RE: Crystal Beach Renovation – Addendum #2

## CRYSTAL BEACH PRE-BID MEETING QUESTIONS

- A. Bidder: \_\_\_\_\_.
- B. Project Name: Crystal Beach Pool and Pool House Renovation
- C. Project Location: Madison, Indiana
- D. Owner: City of Madison, Indiana.
- E. Design Project Number: 20.0400
- F. Architect: KNBA Architects

**U101**

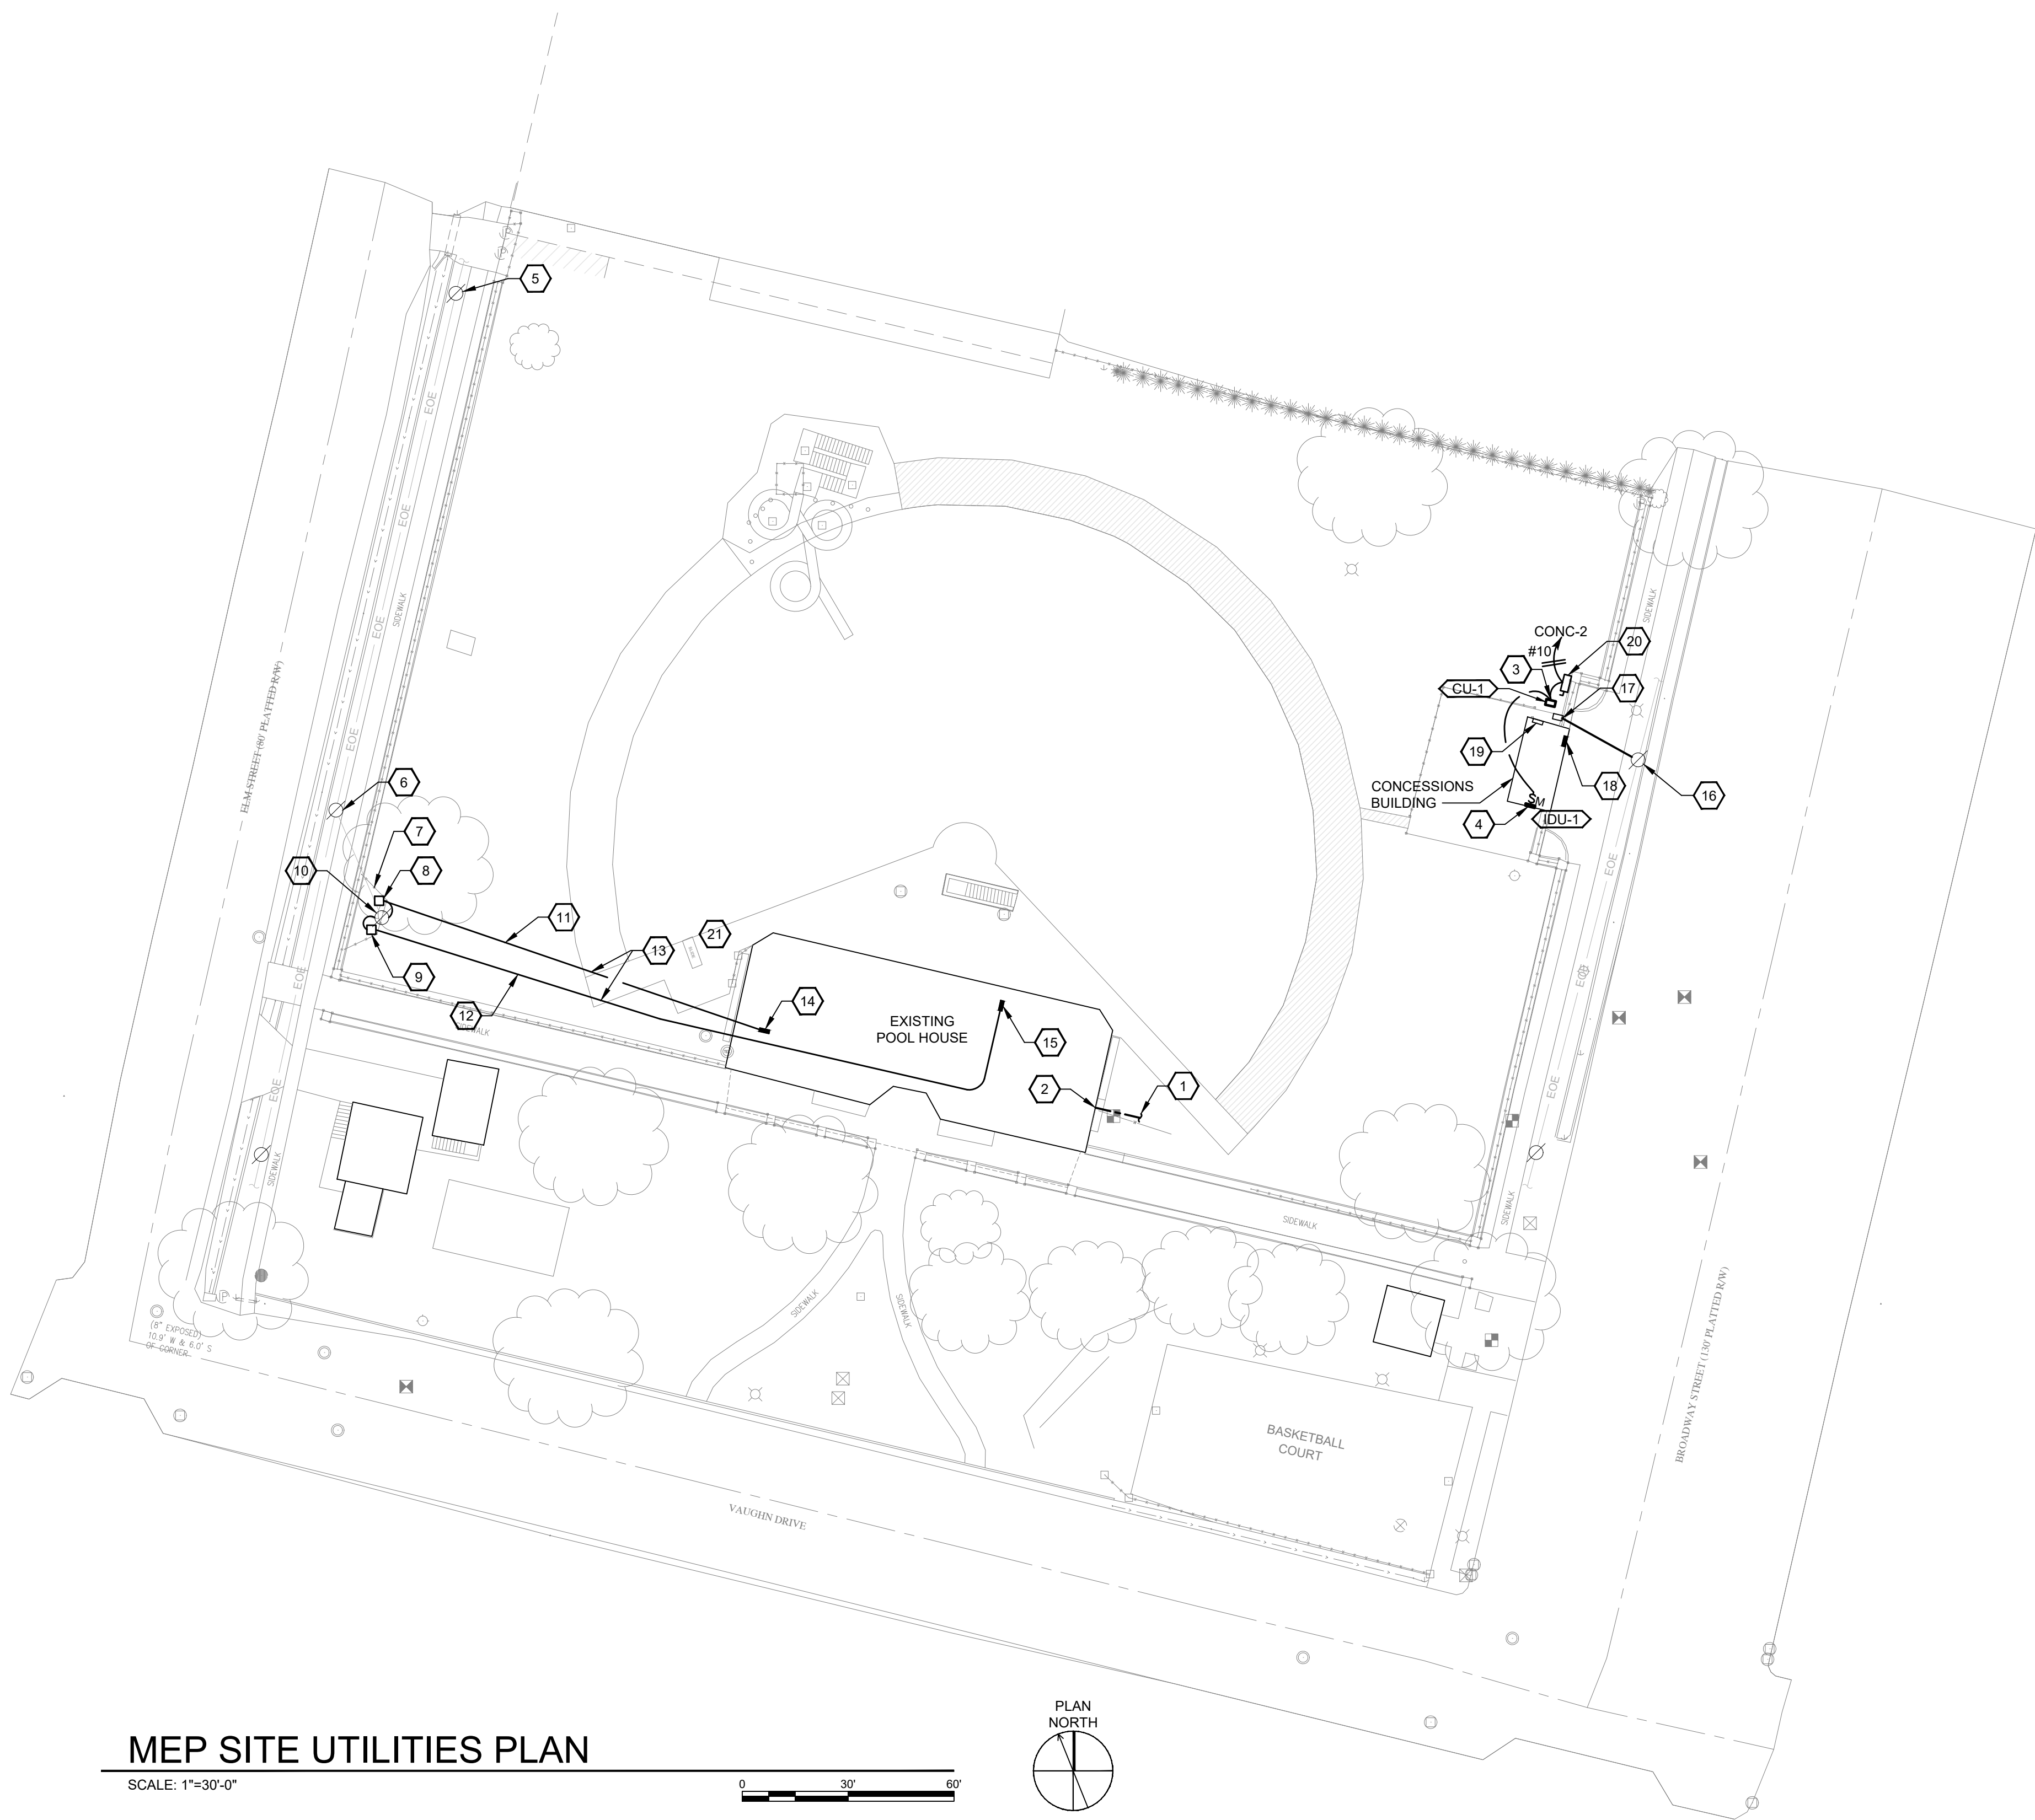
24	Should the reference be to one of the other E series sheets or to a C drawing instead of U101?	See attachment U101.	<i>MEP</i>
3	The pool work is confusing and information lacking. First, there are NO specs on any of that work. Need specs on items like the pool liner, the powered lift, chemical feeders, chemical controllers, flowmeters, main drain covers, etc. etc. Will there be more details provided for the mounting of the powered lift? Does it mount on the pool deck, in the pool wall, etc.?? The civil drawings and pool drawings do not agree on how much of the pool deck is to be replaced. Pool sheets show entire apron being replaced. Civil shows just one side being replaced. Which is correct? Pool drawing refers to drains in the new apron. Where are these required? Specs and details, etc. please. Civil does not address at all. What/where, where they tie in, etc., etc.	See attachments AQ000 and AQ100.	<i>POOL</i>

Item 1: Refer to attached drawing, Sheet U101:

- A. Include Site Utilities Sheet U101 in MEP bid set.
